RE: Request for Advice – 68-80 Banks Avenue, Pagewood – Response to Submissions and Amendment Report- SSDA for Affordable and Market Housing (SSD- 83256472)

Advice on Response to Submissions

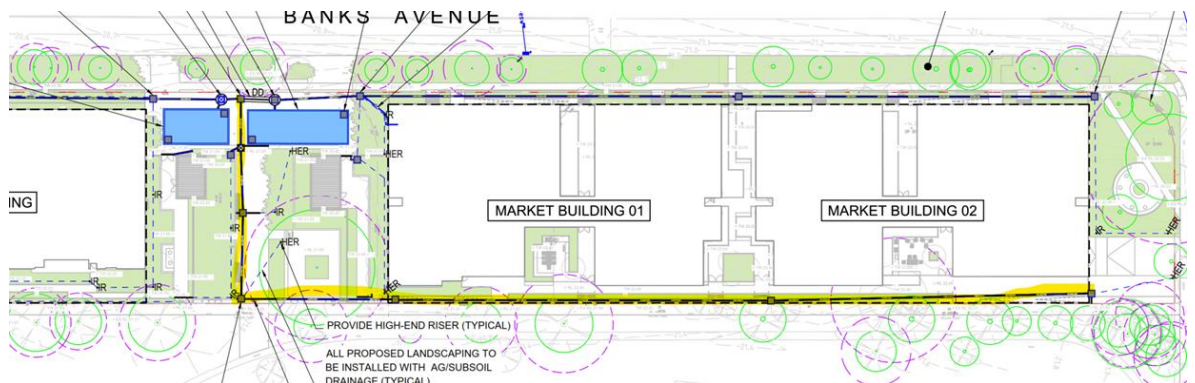
- The MUSIC Model soft copy is to be provided to Council.
- The catchment areas are not coordinated with the ground floor drainage plan as the southern drainage line for the market housing is shown draining into the absorption tank for the social housing. See the image below.

- Overall, the arrangement of drainage on the ground floor is strange, with what appears to be two separate infiltration systems being proposed for each building however a large section of the market building is being drained into the infiltration system for the social building. Additionally, the concrete dish drain connecting the two systems is odd. The buildings need to be designed to ensure that future subdivision of the site separating the ownership of market from social can be achieved without issue. Therefore, two entirely separate drainage systems are necessary draining into two separate infiltration systems.
